ADDENDUM NO. 3
TO GENERAL, MECHANICAL AND ELECTRICAL
ABERDEEN PUBLIC WORKS
MAINTENANCE BUILDING
ABERDEEN, SOUTH DAKOTA

Addendum Dated: March 23, 2026

Original Plans and Specifications Dated: February 20, 2026

1 FIRST FLOOR HVAC PIPING PLAN - AREA B
1/8" = 1'-0"

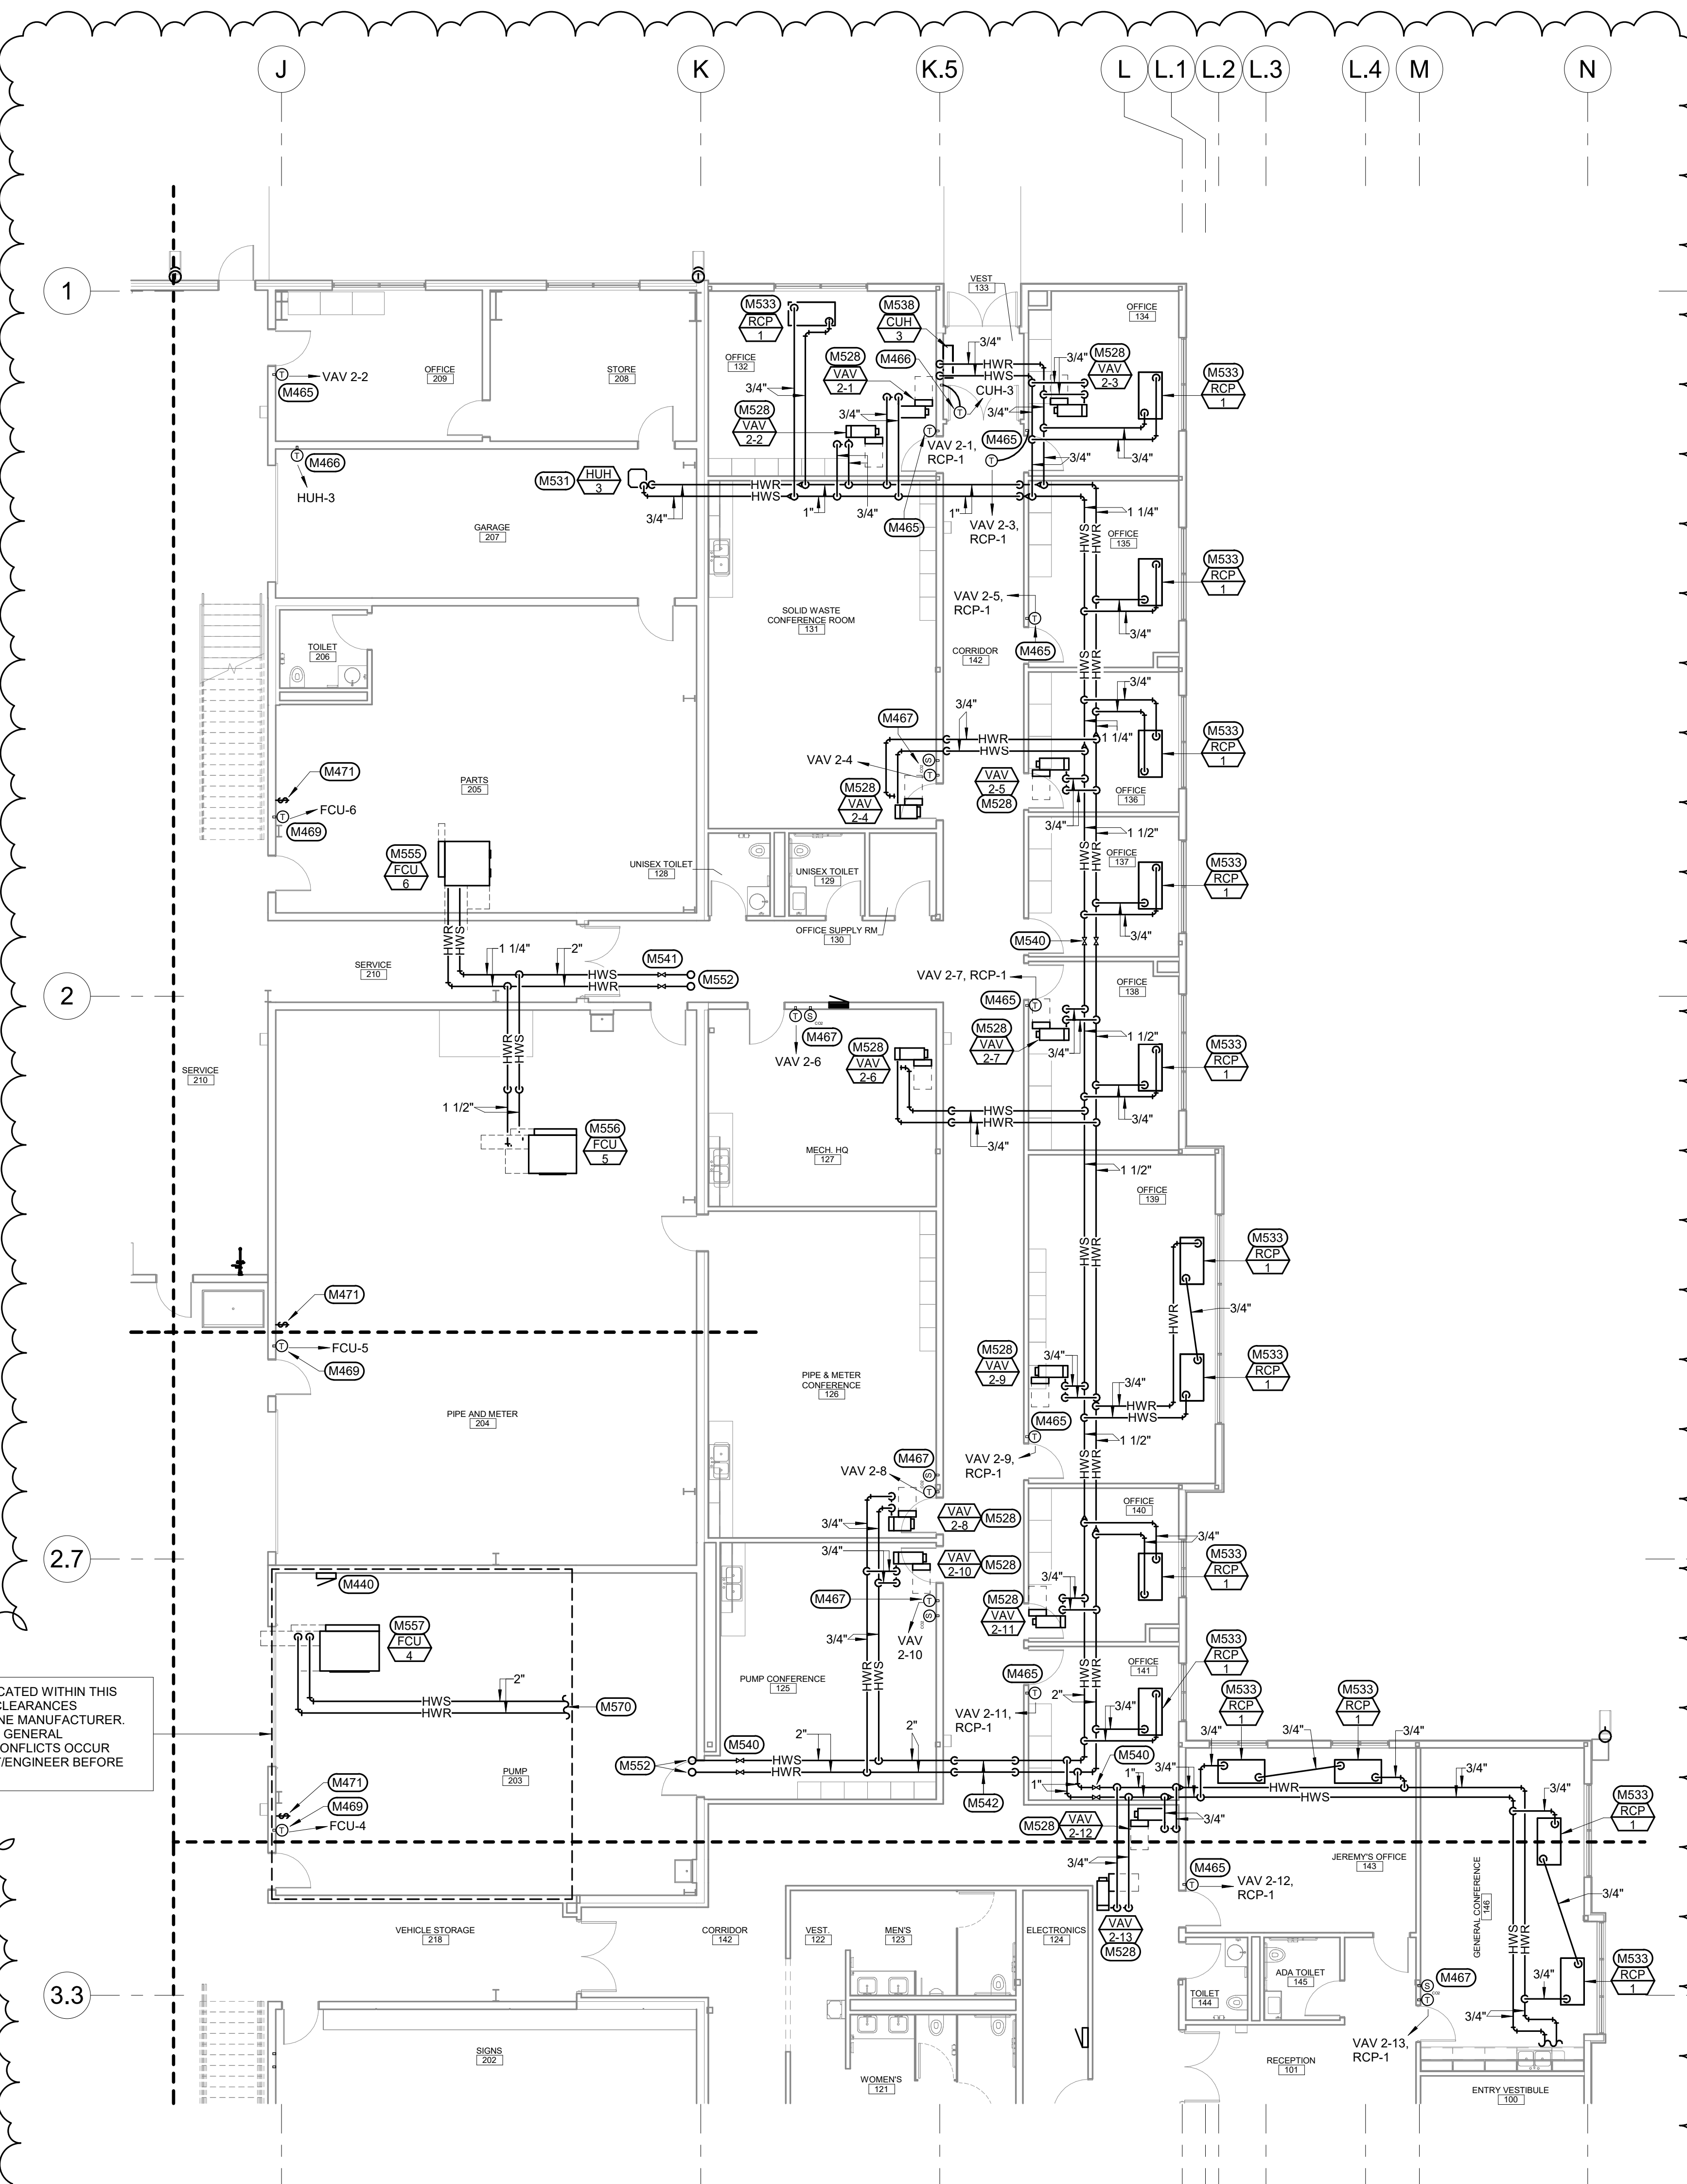
1. See attached sheet for the following revisions:
 - a. Piping sizes updated.

- b. Keynotes added to drawing for clarification.

1 MEZZANINE FLOOR HVAC PIPING PLAN - AREA A
1/8" = 1'-0"

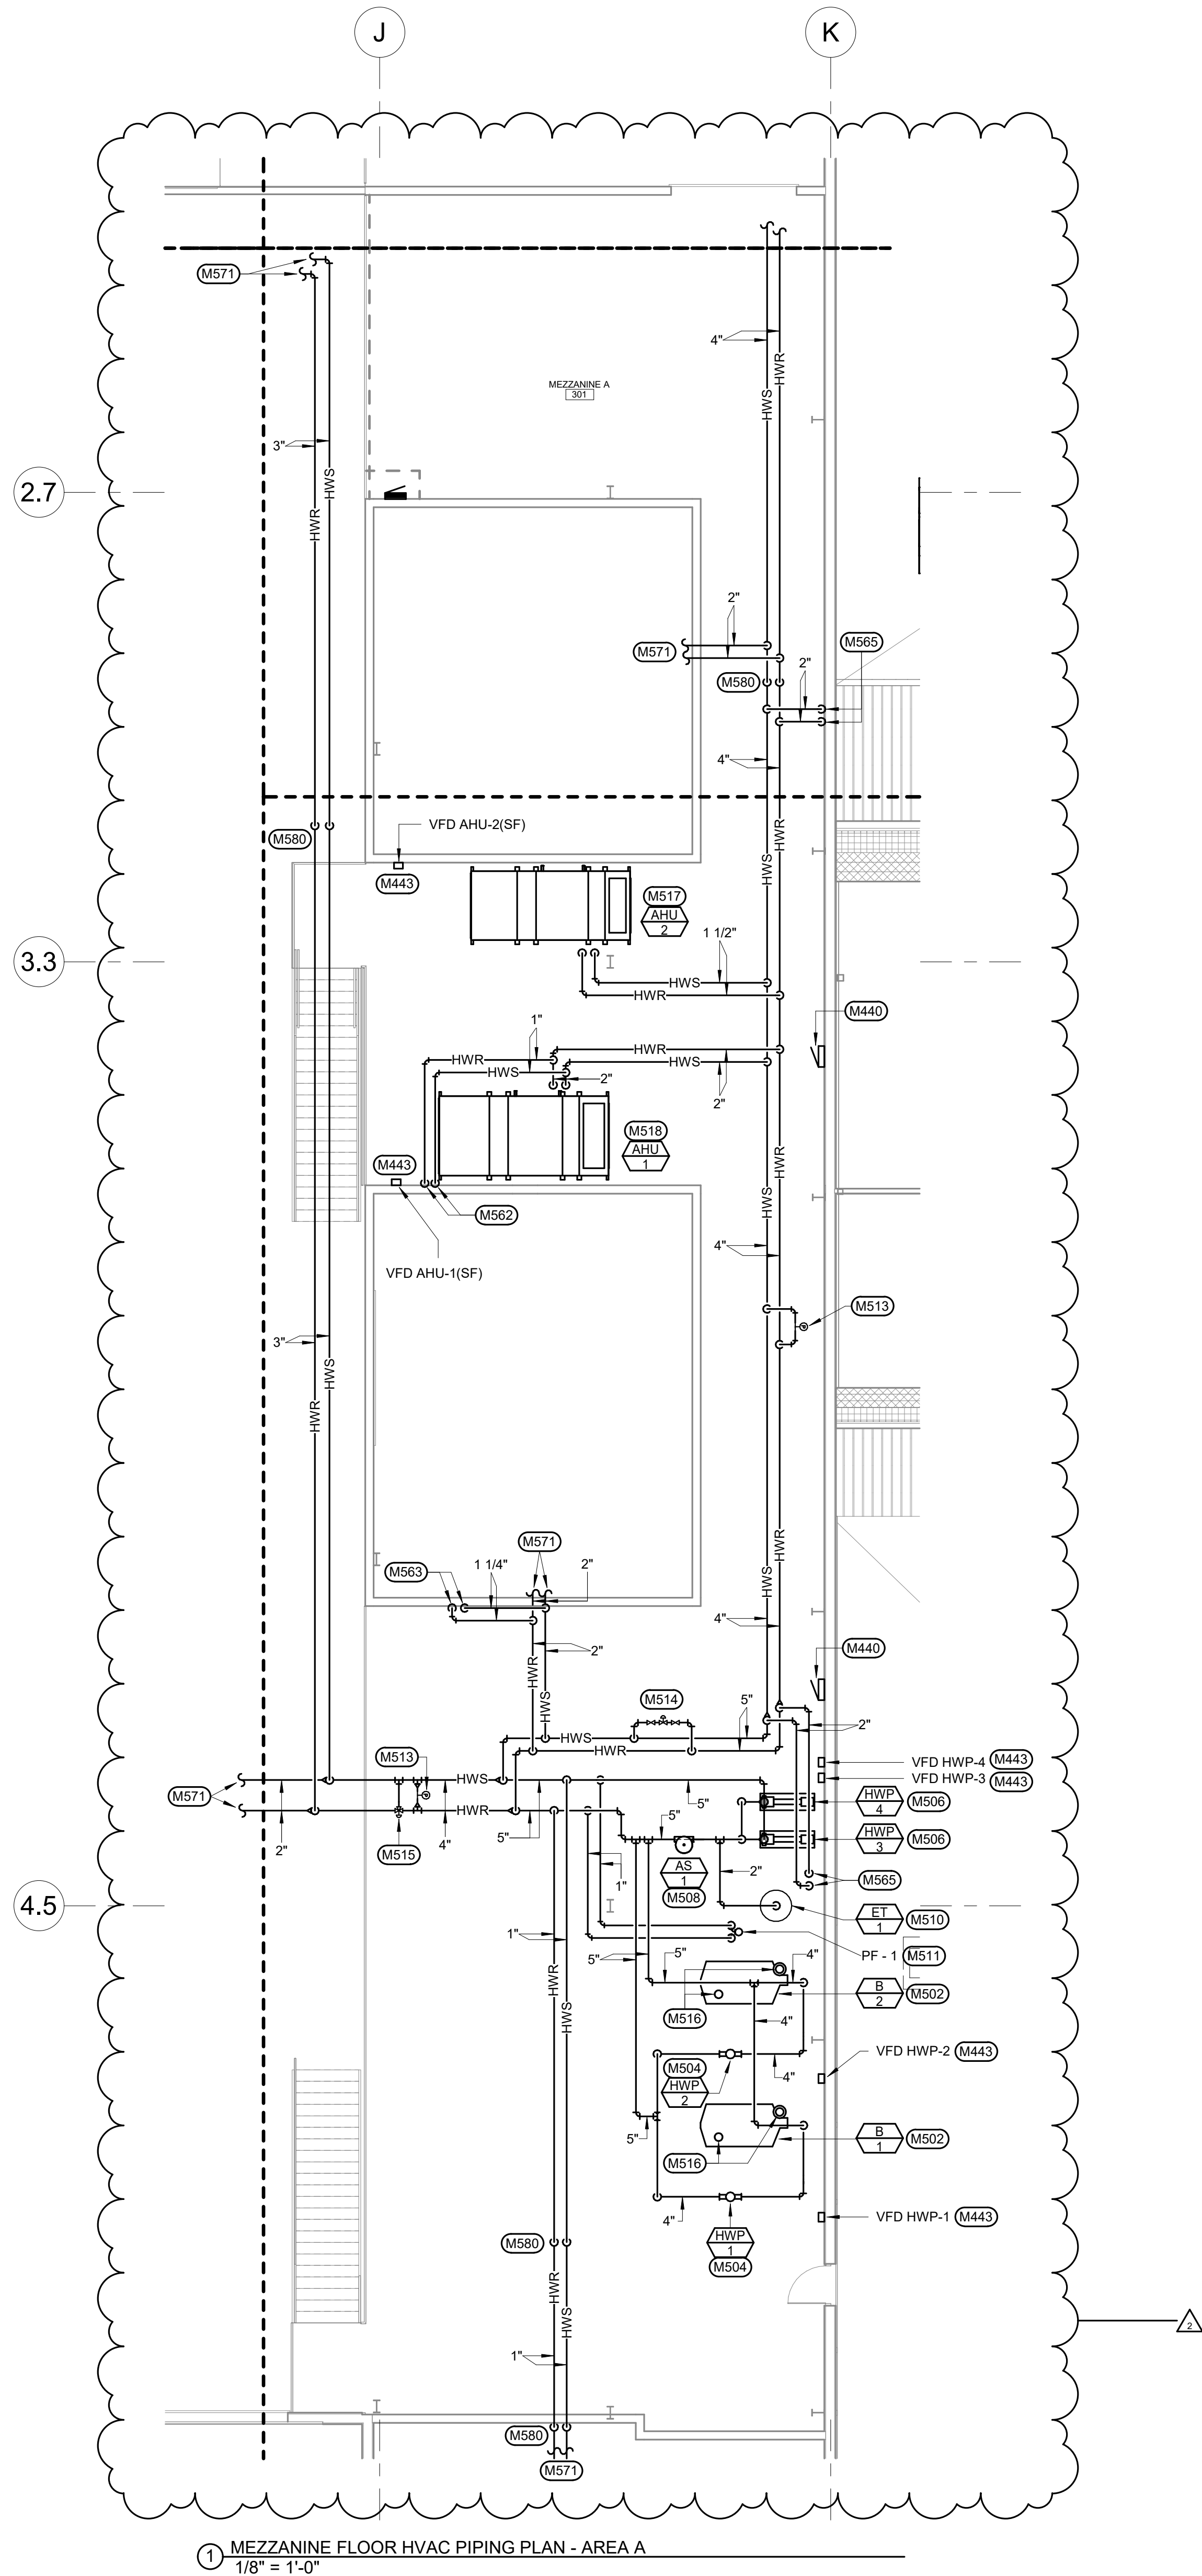
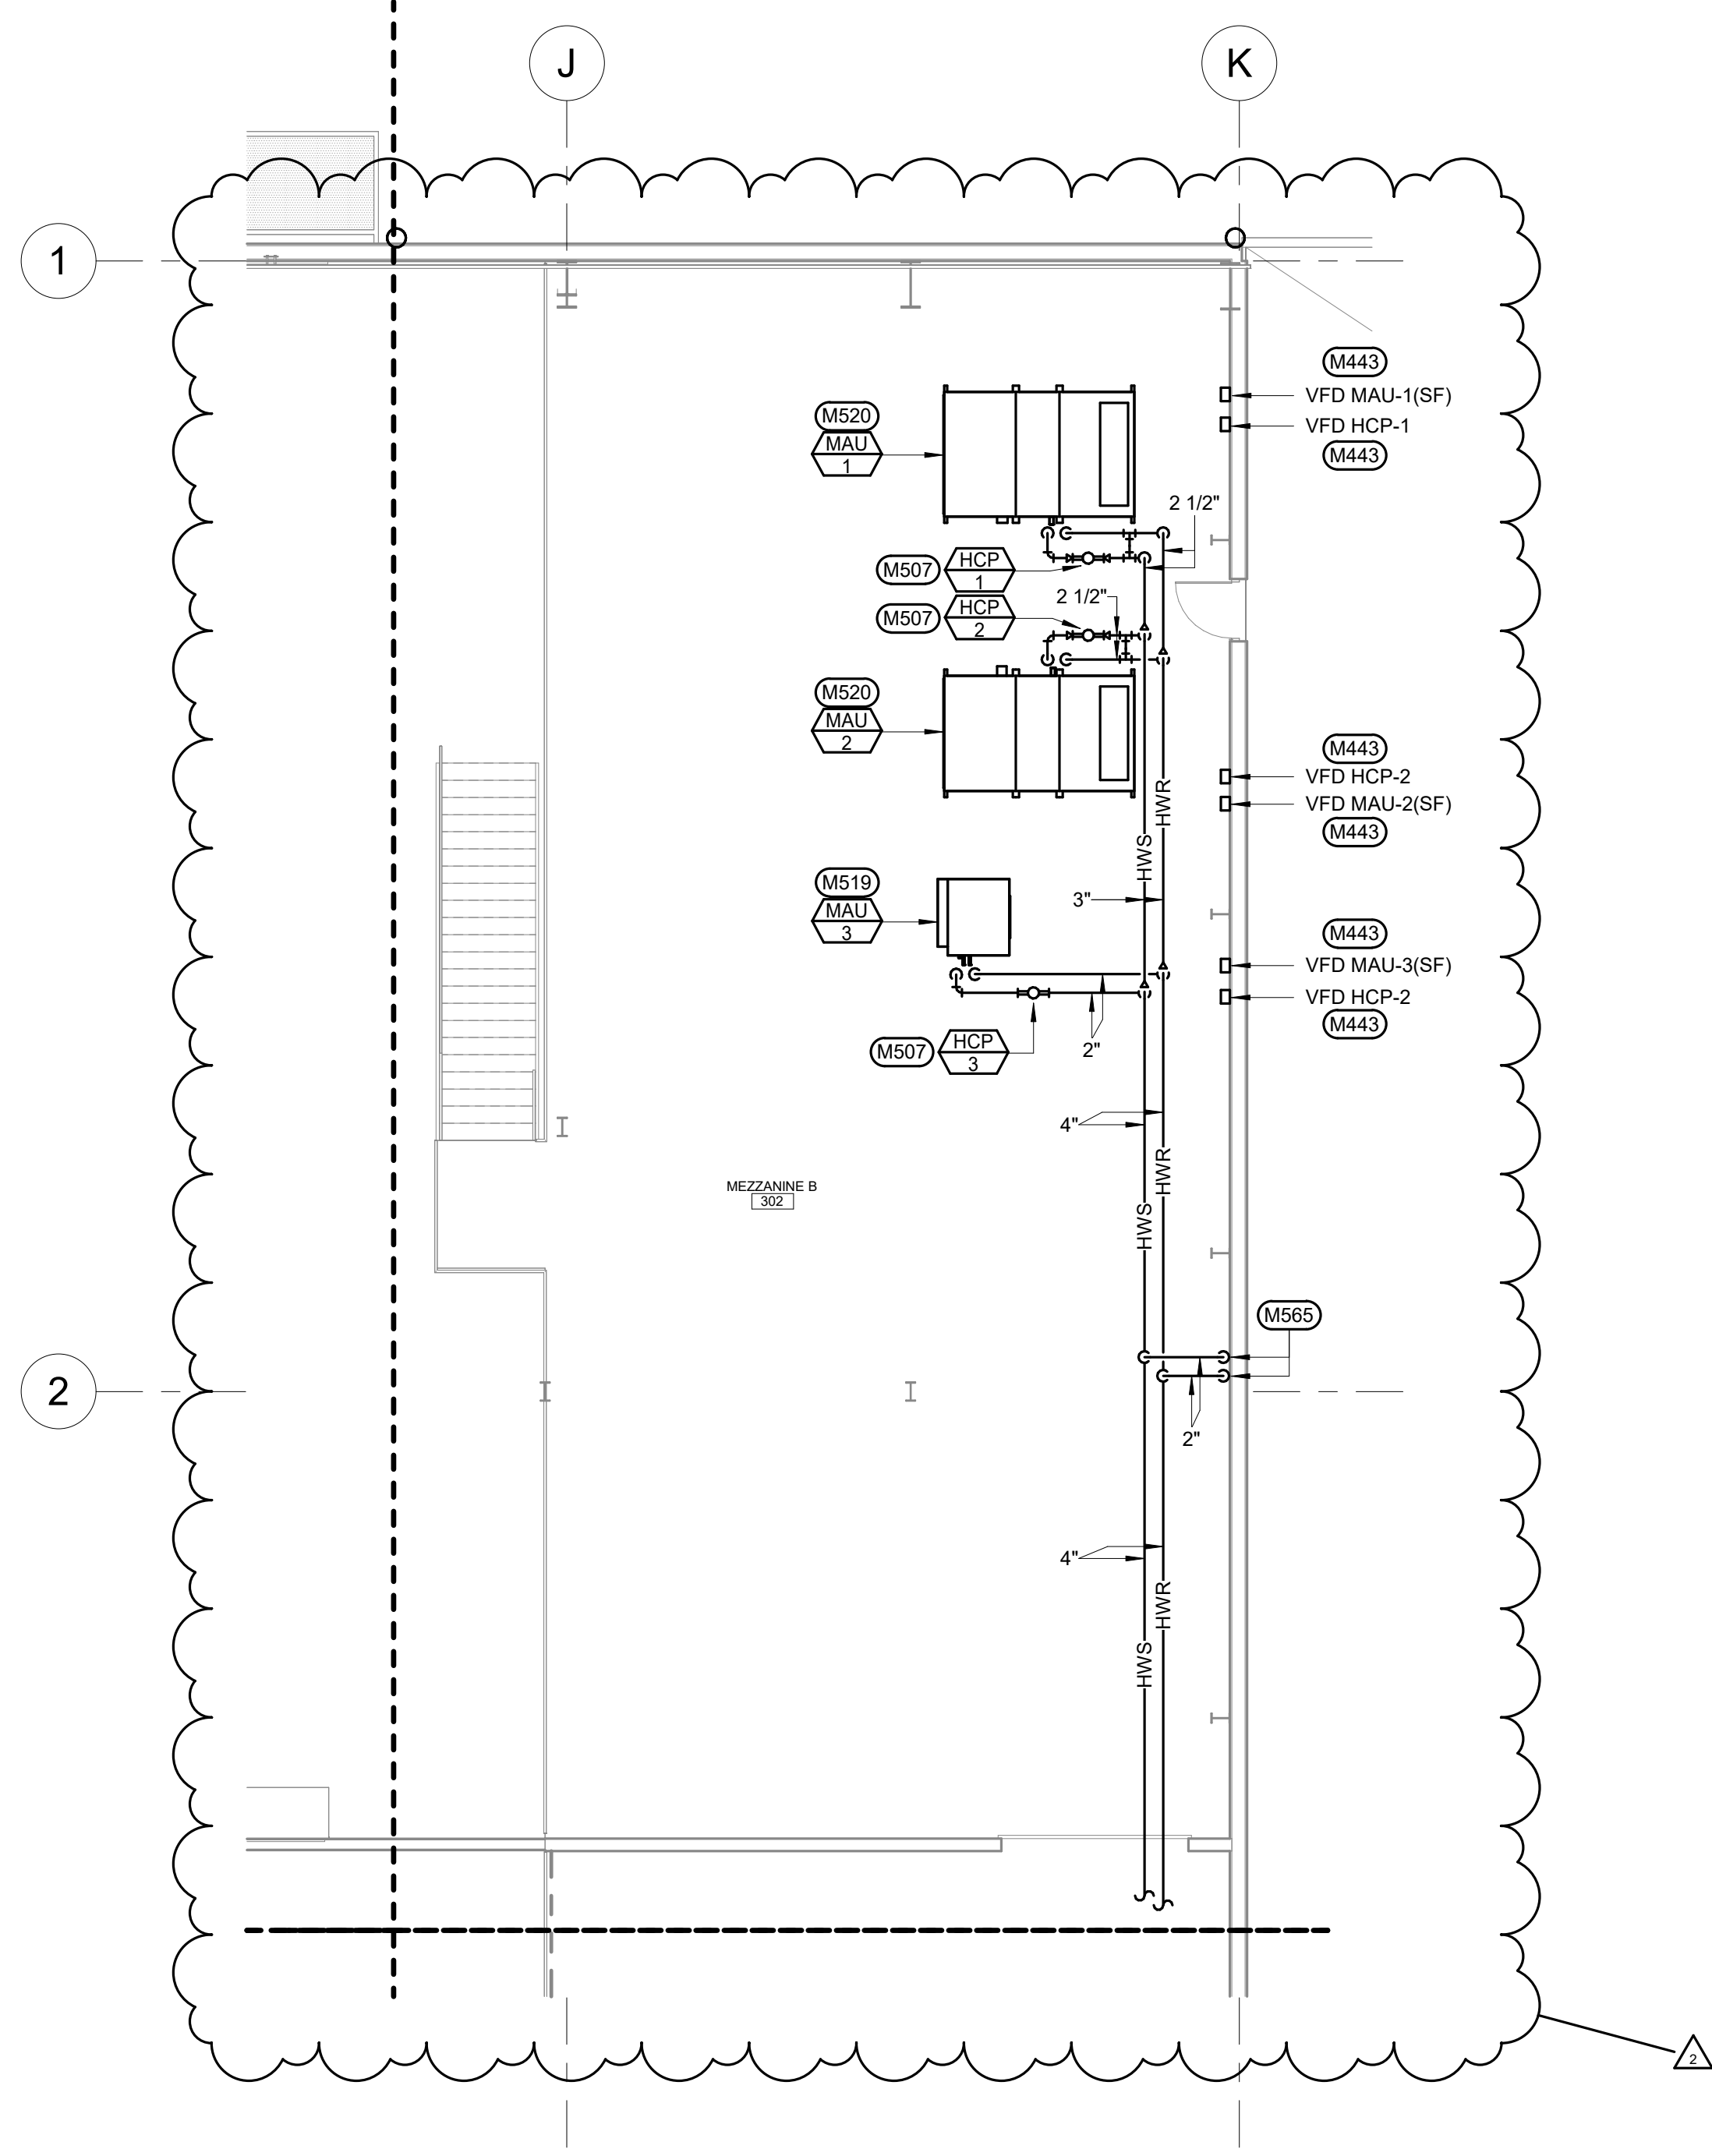
- 1. See attached sheet for the following revisions:
 - a. HWS/R piping modified and sizes and notes added.
